Re: East Goshen Township
Milltown Dam (DEP ID No. D15-146)
2015 Annual Dam Inspection

2015 ANNUAL INSPECTION REPORT

MILLTOWN DAM

DEP ID No. D15-146

Photo No. 1
View of right embankment crest looking toward spillway and Valve House.
Inset shows condition of Danger Sign.

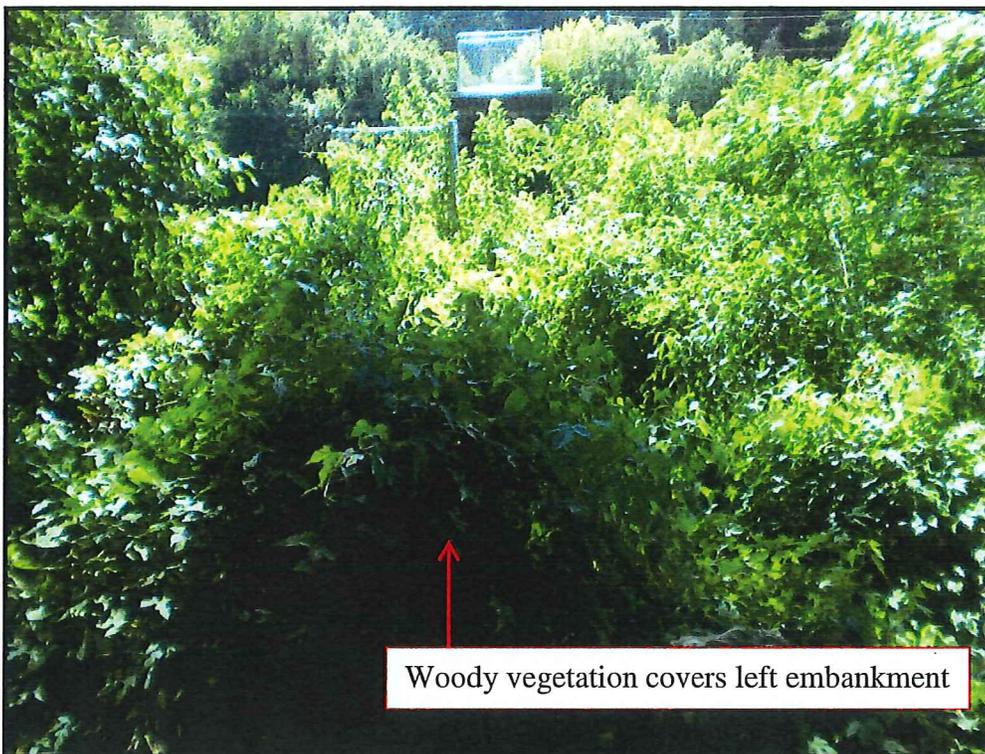
7	Warning Signs	One warning sign observed on swing gate at right abutment. Sign contains graffiti but remains legible (refer to Photo 1). See note below.	<input checked="" type="checkbox"/>	<input type="checkbox"/>	<input checked="" type="checkbox"/>
8			<input type="checkbox"/>	<input type="checkbox"/>	<input type="checkbox"/>
9			<input type="checkbox"/>	<input type="checkbox"/>	<input type="checkbox"/>

Item 7: Maintain warning sign(s) in a condition which is legible and clearly displayed to the public. **Recommend** removing graffiti from warning sign or replacing sign. **Recommend** adding warning sign(s) at left abutment. **Recommend** monitoring area for unauthorized activities.

**Photo No. 11
View of right spillway training wall.**

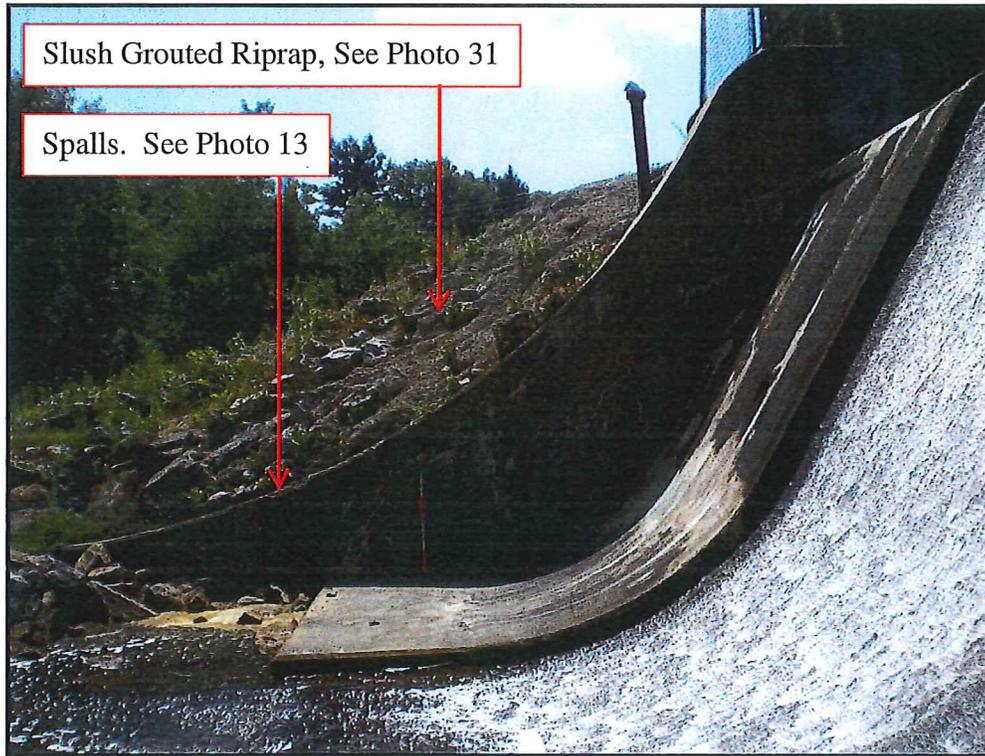
Item 20: Area of riprap on downstream right embankment is slush grouted with concrete. Owner reports slush grout was placed to prevent movement of riprap (refer to Photos 11 and 31).

Item 50: Hairline cracking with efflorescence observed on the vertical portions of both the left and right spillway training walls (refer to Photos 11, 12, 15 & 16). Several spalls observed near downstream end of right spillway training wall (refer to Photo 13). **Recommend** monitoring concrete for changes in condition which may require additional repairs.

Recommend repairing spalled concrete on right spillway training wall.

**Photo No. 15
View of left spillway training wall.**

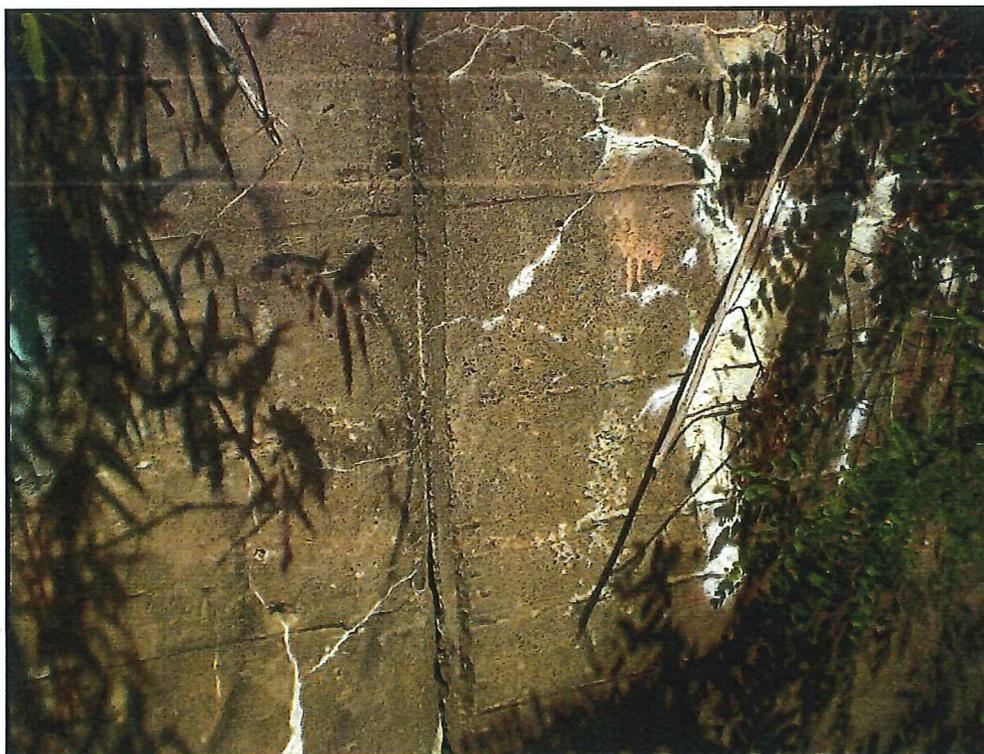
Item 51: Epoxy coating on ogee spillway face installed in 2013 observed to be failing. Multiple areas observed where the coating has peeled away from the concrete (refer to Photos 14 and 15). Various other areas of surface patchwork observed. Township reports that the epoxy coating will be repaired this fall. **Recommend** replacing the epoxy coating as currently planned by the Township.

**Photo No. 20
Chain link fence on downstream side of Valve House. Note missing top rail.**

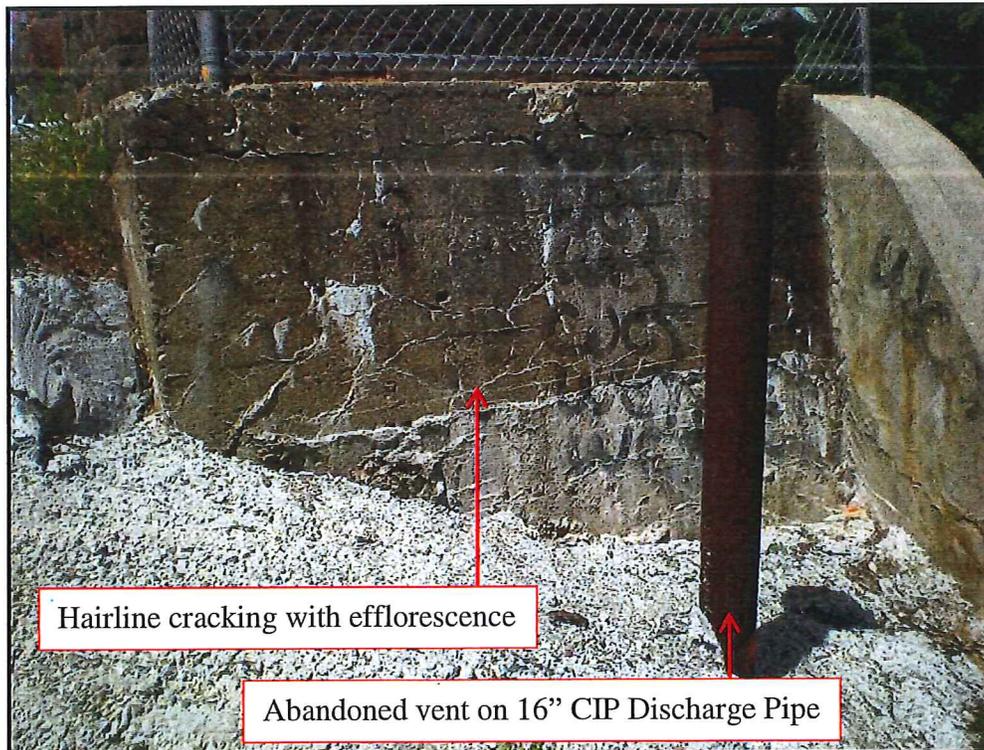
Item 46: Refer to Item 7 for warning sign recommendations. Top support post on chain-link fence at Valve House is missing (refer to Photo 20). **Recommend** repairing fence.

Photo 27

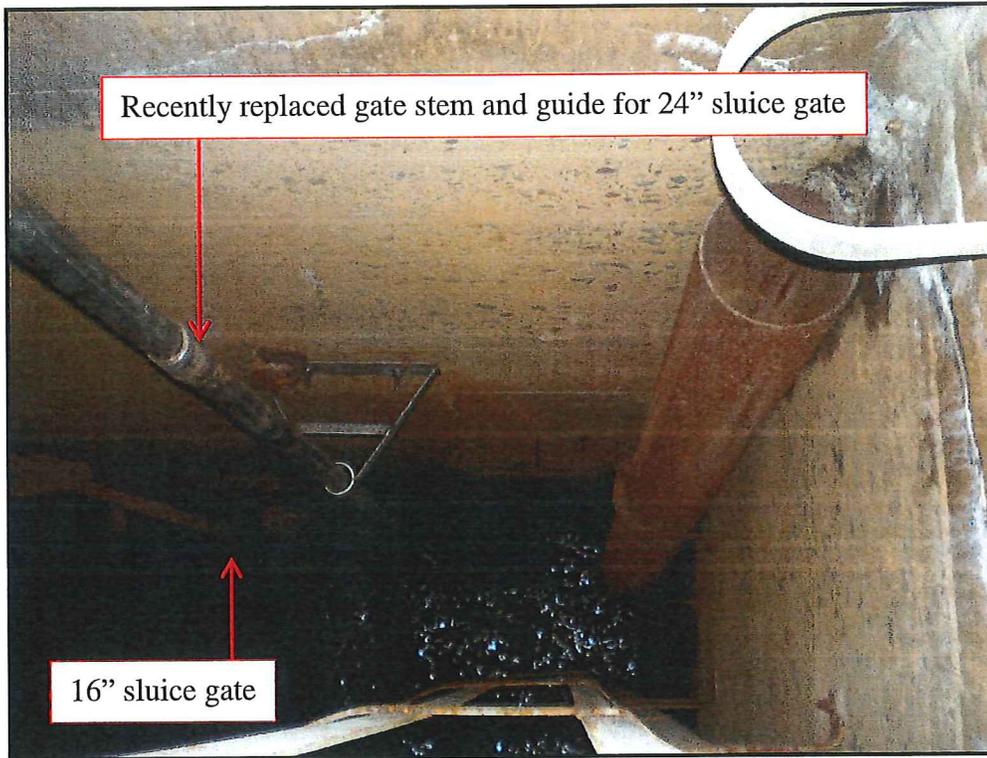
Item 59: Sluice gates were observed on the 16" and 24" CIPs entering and leaving the Valve House (four gates total) controlled by manually operated handwheels (refer to Photos 25, 26, 27 & 28). The upstream 16" sluice gate was operated at time of inspection. The upstream 24" sluice gate was unsuccessfully operated due to connection failure between the gate stem and gate. *Post inspection note: Township reported on 8/19/15 that 24" gate has been repaired and is operable.* Downstream gates are inoperable with the 16" gate frozen in the closed position and the 24" gate frozen in the open position. Downstream gates are not required for the operation of the low level dewatering system. East Goshen Township reports that the downstream 16" CIP has been abandoned and plugged at an unknown location downstream of the dam. Valve House constructed of masonry with lockable door and observed to be in fair condition (refer to Photos 19, 21 & 23). Hairline cracks with efflorescence observed on exposed exterior portions of the valve chamber (refer to Photos 22, 23 & 24). Dampness with efflorescence observed in the interior downstream left corner of the concrete valve chamber (refer to Photo 28). **Recommend** monitoring the condition of the concrete valve chamber for changes in condition which may warrant repairs.
